## TECHNICAL BULLETIN: AIRTRONIC AX3 FUEL SPIGOT CONNECTOR

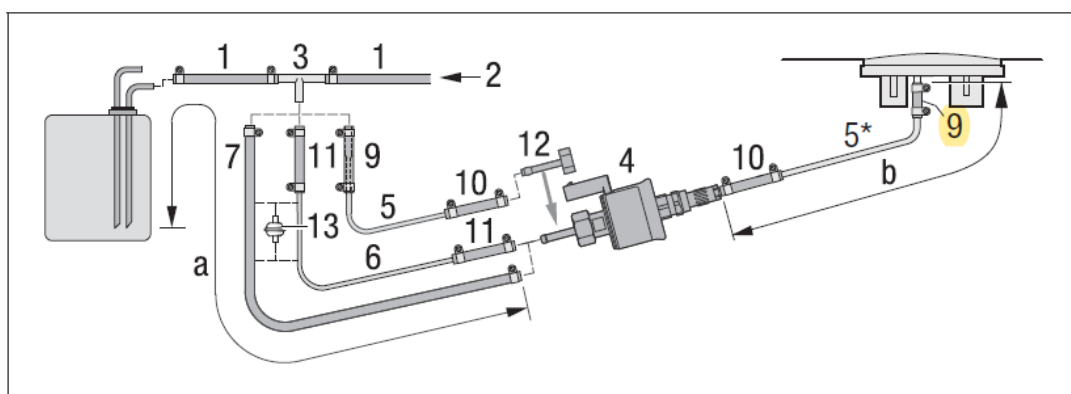
Due to an increase in the fuel spigot diameter on the latest range of AX3 heaters, there is a different fuel spigot connector supplied in the new AX3 kits. This is identified as item 9 on page 33 of the latest technical description (highlighted below).

Please ensure that this new connector is orientated correctly, with the larger diameter (Ø4.5) fitted to the heater fuel spigot, and the smaller diameter (Ø3.5) fitted to the blue fuel line.
